NEVADA REGIONAL HAZE REVISION TO THE STATE IMPLEMENTATION PLAN FOR THE SECOND PLANNING PERIOD

Revision to the Plan for Implementing
Section 308 (40 CFR § 51.308)
of the Regional Haze Rule
Second Implementation Period (2018-2028)

Public Comment Draft

February 28, 2025

Figure 1 - North Valmy Generating Station - Future Electric Output Projections

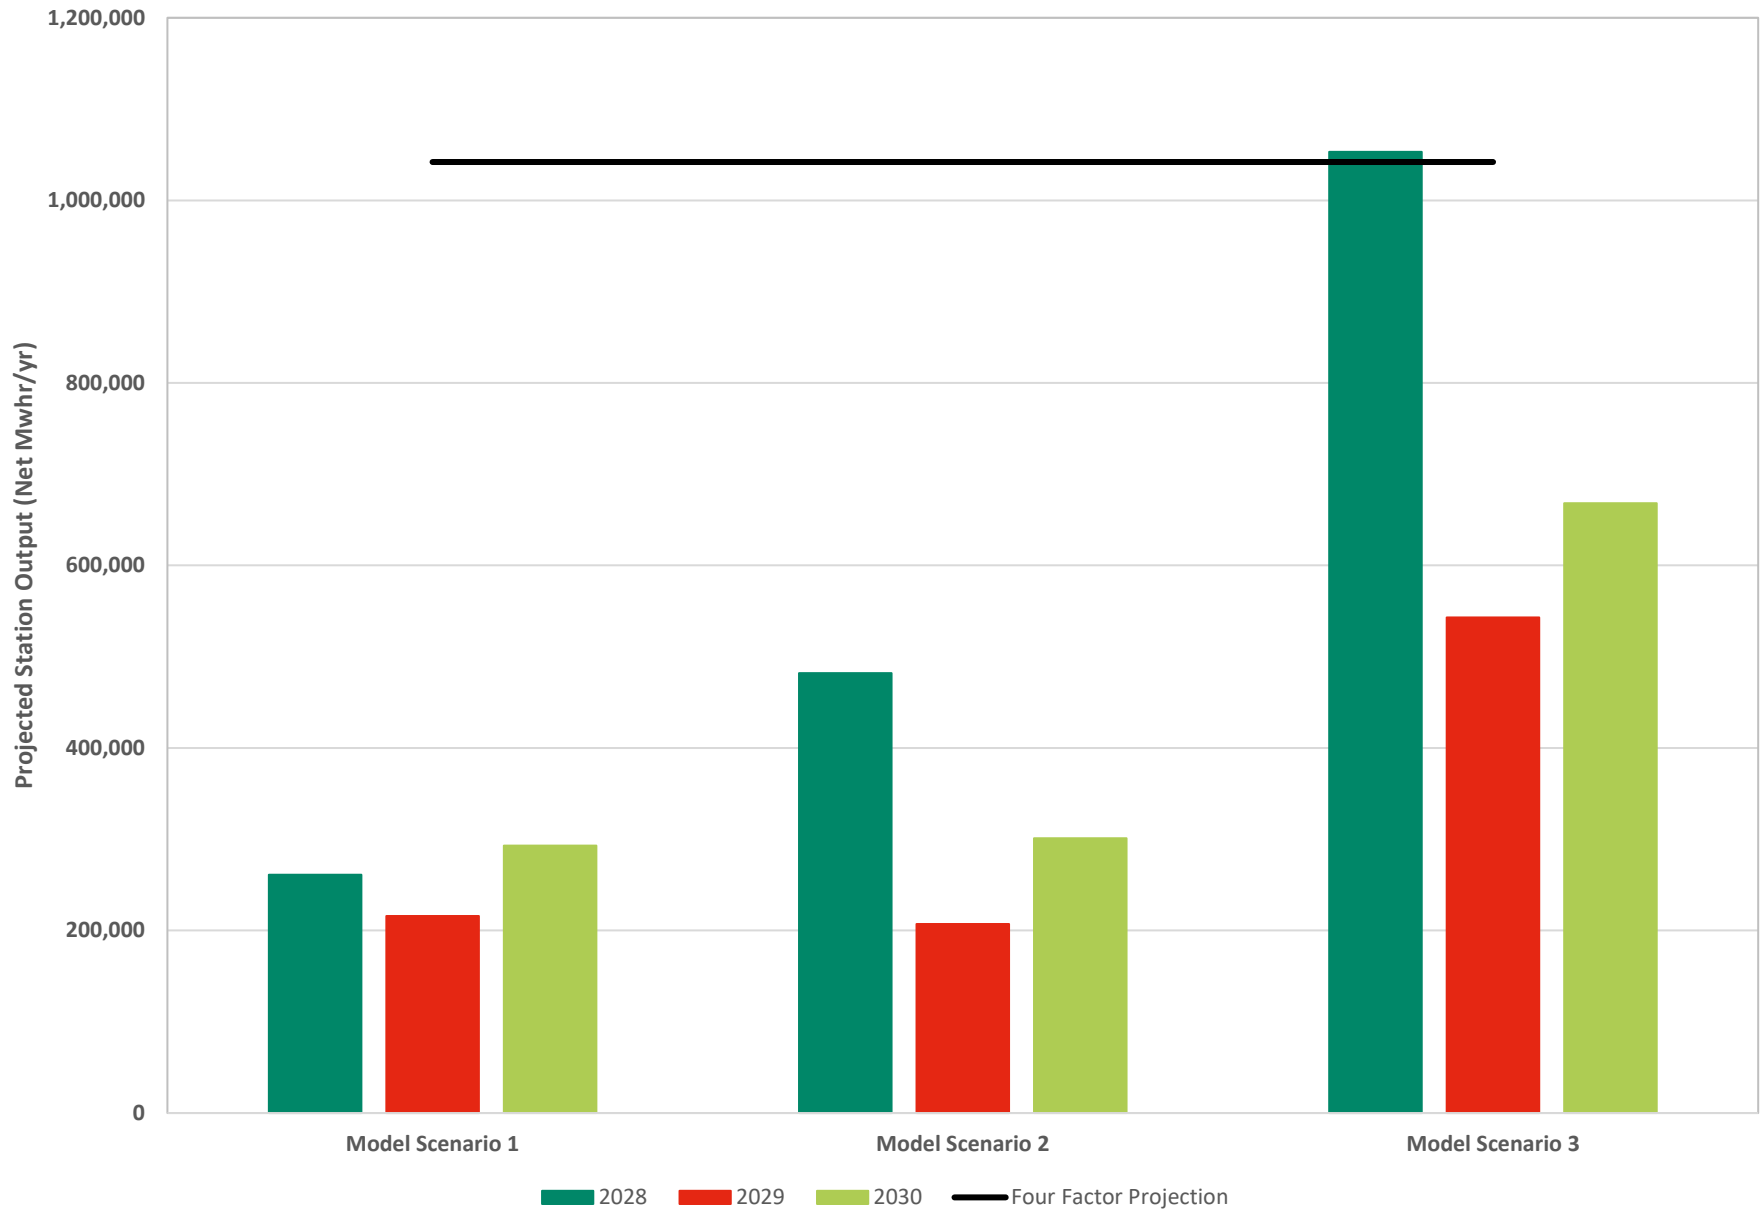
NDEP Request 1: Please provide the forecasted generation data used to prepare Section 1.1.2, Figure 1, in the updated Four Factor Analysis.

Attachment 1 to this response letter provides a tabulation of forecasted generation data for 2028 to 2030 for NV Energy and Idaho Power forecast used to create Figure 1. The scenarios included are discussed in Section 1.1.2 of the updated Four-Factor analysis.
